RE: CPUC Data Request #10 for PG&E's Moraga to Oakland X 115 Kilovolt Rebuild Project (A.24-11-005)

PEA Chapter 3, Project Description

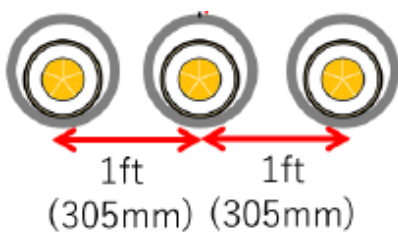
PD-17 In rationalizing the change from the design in the 2019-202 Transmission Plan, the PEA (p.2-4) says: "Since 2020, modern cable type technology allows rebuilding four lines instead of three lines within limited ROW and city franchise streets..." Please elaborate on how the proposed "modern" cable can be placed closer together, and how the proposed 115 kV cable of a copper cross-linked polyethylene (XLPE) triplex type can be placed closer together than the previously considered option.

The original cable type, a traditional XLPE (refer to Single Core image), arranges the three cables, one for each phase of the circuit, in separate conduits in a flat, vertical, or triangular configuration. None of these configurations align the three phases symmetrically. The proposed cable technology type, a triplex XLPE, installs the three cables symmetrically in a helical (spiral curve, or twisted triangular) configuration in a single conduit (refer to Triplex images).

Triplex cables are bundled together symmetrically in the conduit throughout the circuit. The difference in cable symmetry results in different induction. With the single core cable, the phases are not symmetrically aligned and the circuit produces an electromagnetic force greater than the symmetrical triplex cable. An electromagnetic force induces a voltage on nearby conductive objects (such as a nearby deenergized line). Although safety measure such as grounding are installed, a nearby deenergized line could become charged from the induced voltage of the energized line and would be a potential shock hazard to maintenance workers. To avoid an electrical shock hazard in addition to other safety measures, single core cables are installed at least 15 feet apart or both lines are deenergized before work begins. With the triplex phase/cable symmetry, each phase/cable cancels out or minimizes the electromagnetic force emitted by the other phases/cables. This phenomenon can be visualized by applying right-hand rule in electromagnetism. The minimized electromagnetic force allows two triplex cables to be placed closer together without the potential maintenance worker shock hazard of single core cables, or needing to deenergize both cables. Two triplex cables can be installed safely at less than 15 feet apart, which includes being installed in one double-circuit duct bank as the project proposes. The 15-foot circuit separation between adjacent double-circuit duct banks discussed in the PEA maintains ampacity by avoiding mutual heating the adjacent triplex cable double-circuit duct banks (PEA at page 4-15).
